Client  
 RFU  
 Project  
**TWICKENHAM STADIUM EAST STAND EXTENSION**

**PROPOSED LANDSCAPING SECTIONS**

Doc ref	Project number	Drawing number	Revision
100-KSS-DR	15735	007	P02

**3 SECTION**  
 LANDSCAPE SECTION 3  
 1 : 100

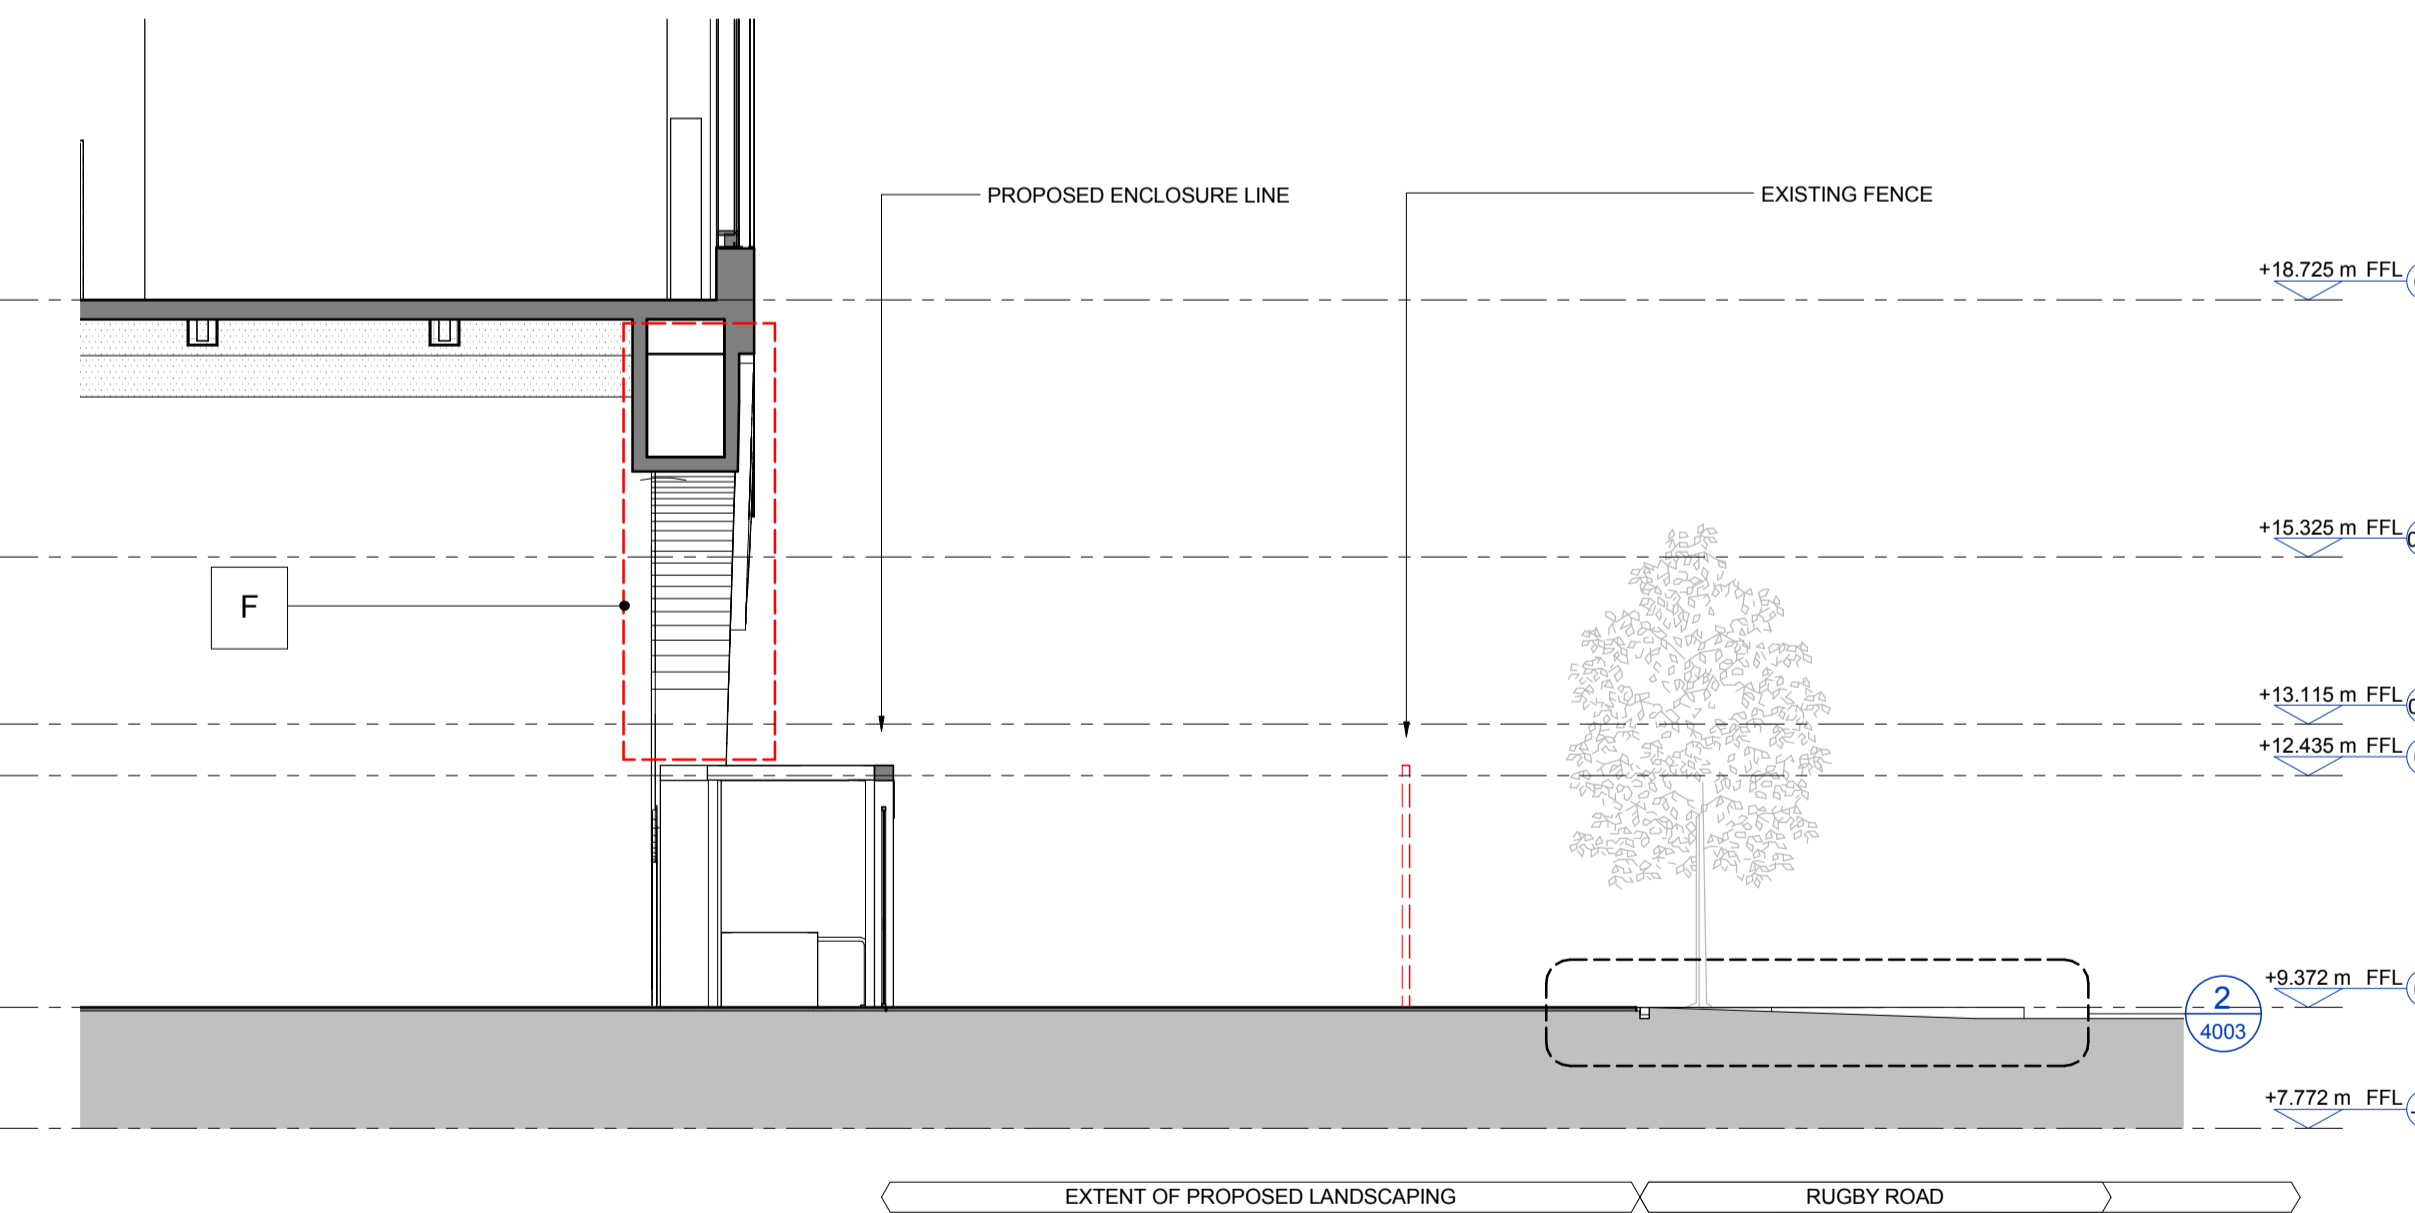
- A GENERAL AMENDMENTS TO THE SOUTH END.
- A1 INCREASED SHINGLES CLADDING AREA AND CURTAIN WALL REDUCED ACCORDINGLY.
- A2 REDUCED MASSING AND REVISED INTERFACE WITH THE SOUTH STAND.

- B PPC LOUVRES LOCATED TO THE BOWL SIDE HAVE BEEN OMITTED.
- C CURTAIN WALL SETTING OUT REVISED GENERALLY. SILICONE JOINTS TO TRANSOMS AND MULLION REPLACED WITH CAPPED SYSTEM. LEVEL 04 PPC LOUVRES SETTING OUT & HEIGHT REVISED. MONORAIL FOR ABSEILING REMOVED.

- D GENERAL AMENDMENTS TO THE CENTRAL ELEVATION CANOPY AT LEVEL 5A REVISED GENERALLY AND STANDING SEAM REPLACED WITH SINGLE PLY MEMBRANE. SUPPORT COLUMNS TO ROOF CANOPY REVISED. SQUARE FASCIA TO ROOF EDGE.

- D1 LEVEL 5A GLAZED SCREEN EXTENDED IN HEIGHT AND PPC LOUVRES INCLUDED AT LOW LEVEL.
- D2 INCREASED SHINGLES CLADDING AREA AND CURTAIN WALL AREA REDUCED ACCORDINGLY. FOUR VERTICAL FINES REMOVED.

- D3 PORCELAIN PANELS WITH SLOTTED HOLES FOR VENTILATION REPLACED WITH PPC LOUVRES. EXPRESSED HORIZONTAL PATTERN TO PORCELAIN PANELS OMITTED.
- E GENERAL AMENDMENTS TO THE NORTH END

- E1 PORCELAIN CLADDING REPLACED WITH PPC ALUMINIUM CLADDING.
- E2 GREEN WALL TO THE NORTH END EXTENDED AND PPC LOUVRES REMOVED.
- E3 INCREASED SHINGLES CLADDING AREA AND CURTAIN WALL REDUCED ACCORDINGLY.

- F FENCELINE, GATE AND PERIMETER COLUMNS SETTING OUT REVISED.
- F1 CANOPY TO TURNSTILES REVISED.
- G PORCELAIN PATTERN CHANGED FROM HORIZONTAL TO VERTICAL.

- H PORCELAIN PANELS TO THE SOFFIT OF THE ARCH REPLACED WITH PPC ALUMINIUM PANELS. PORCELAIN PANELS SETTING OUT REVISED.
- K ROOF TO LEVEL 5A (NORTH END) EXTENDED.

- L GLAZED SPANDREL PANELS REPLACED WITH METAL SPANDREL PANEL. PORCELAIN PANELS REPLACED WITH PPC ALUMINIUM CLADDING.
- L1 PPC LOUVRES INCLUDED FOR MECHANICAL VENTILATION.
